Access Compliance Report Public Rights-of-Way (Curb Ramps)

Main Street: N/A		Cross Street: ESPERANZA_RD		Location:	NE
ADA ID: RPAT210923133953	Ramp Type:Type 1 - Perpendicular	Initial Pass/Fail: Fail	Overall Compliance: No	Severity Score:	30

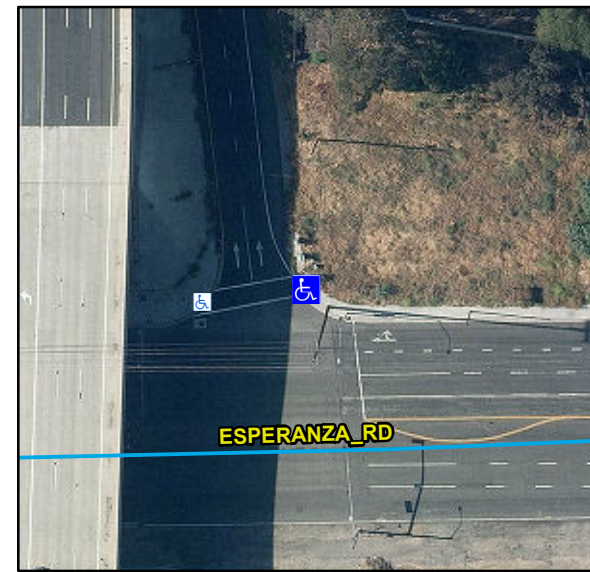
Codes/Mitigation Info/Possible Solution			Field Measurements/Component Compliance		
---	--	--	---	--	--

Compliance	Description	Data	Compliance	Description	Data
N/A	Ramp Length (in)	56	N/A	Flare Type LT	
Yes	Ramp Width (in)	93			N/A
No	Ramp Run Slope (%)	9.1	N/A	Flare Slope LT (%)	N/A
Yes	Ramp Cross Slope (%)	0.6	N/A	Flare Traversable LT	N/A
N/A	Landing Present	N/A	N/A	Flare Type RT	
N/A	Landing Length (in)	N/A			N/A
N/A	Landing Width (in)	N/A	N/A	Flare Slope RT (%)	N/A
N/A	Landing Run Slope (%)	N/A	N/A	Flare Traversable RT	N/A
N/A	Landing Cross Slope (%)	N/A	N/A	DWS Provided	N/A
N/A	Landing Movement Obstructed?	N/A	N/A	DWS Contrast	N/A
	Landing Movement Type	N/A	N/A	DWS Length (in)	N/A
N/A	Landing Shared	N/A	N/A	DWS Full Width	N/A
N/A	Clear Space	N/A	N/A	DWS Offset Left (in)	N/A
N/A	Clear Space To Crosswalk (in)	N/A	N/A	DWS Offset Right (in)	N/A
N/A	Marked Crosswalk 1	Yes	N/A	Marked Crosswalk 2	N/A
	Crossing 1 Direction	W		Crossing 2 Direction	N/A
	Marked Crosswalk 1 Width (in)	120		Marked Crosswalk 2 Width (in)	N/A

N/A	Ramp Inside Crosswalk 1	Yes	Yes	Ramp Inside Crosswalk 2	N/A
	Crossing 1 Slope (%)	4.4		Crossing 2 Slope (%)	N/A
	Crossing 1 Cross Slope (%)	3.3		Crossing 2 Cross Slope (%)	N/A
N/A	Gutter Ponding	N/A	No	Curb Slope	12.7
Yes	Gutter Lip Height (in)	0		Road Run Slope (%)	N/A
N/A	Gutter Run Slope (%)	N/A		Road Cross Slope (%)	N/A
N/A	Gutter Cross Slope (%)	N/A			
No	Overall Surface Condition:	Poor	Yes	Perp Joint Present	Yes
	Cross Gutter Present?	No		Spandrel Present?	No
	Replace Cross Gutter?	N/A		Replace Spandrel?	N/A

Remove & Replace Entire Ramp.

R304.2.2, R302.7, STD 1115
